PERCOLATION TESTING

A 09342

THOMPSON DRIVE

PERCOLATION TEST PLAT
 Property of
 Benedict Buksa, Jr.
 Deed 684/248
 3rd Election District
 Howard County, Maryland
 Scale 1"=50'
 Date 6-24-81

Lot 9 Thompson Dr.

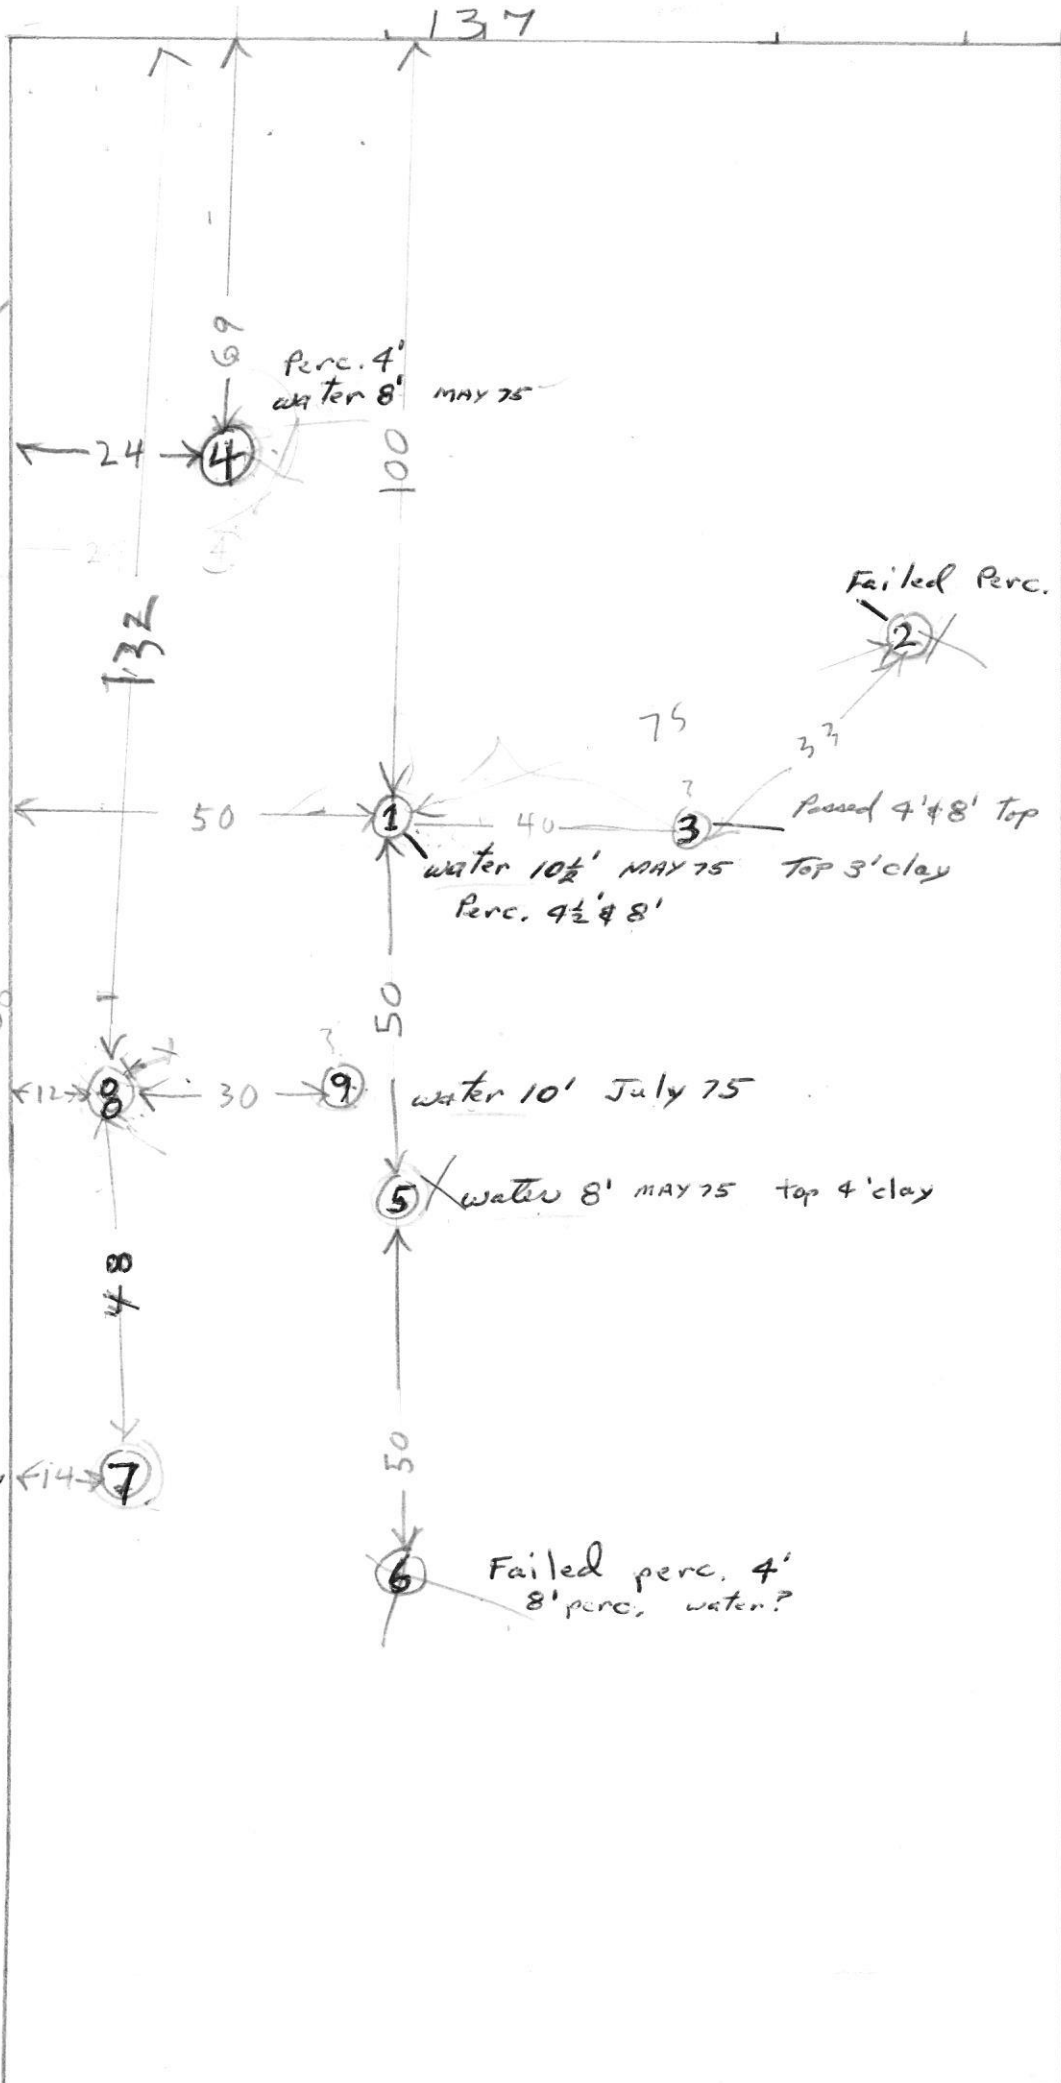
6/9/81 T.C. & Mr. Buksa shaded area acceptable for drain fields. Mr. Buksa informed perc plot required. Copy of this worksheet & topo given to Buksa F.S.

7/24/81 Visited property to check hole locations submitted by Carl Hodgins. Lot was tested at its very highest point, lot drops off to rear & is heavily wooded. Lot not acceptable for drain fields F.S.

7/27/81 T.C. & Ben Buksa & informed him that lot is not acceptable for drain fields. He mentioned possibility of buying higher ground from neighbor Geisler to be able to get good perc. I told him it must be tested in WET SEASON ONLY F.S.
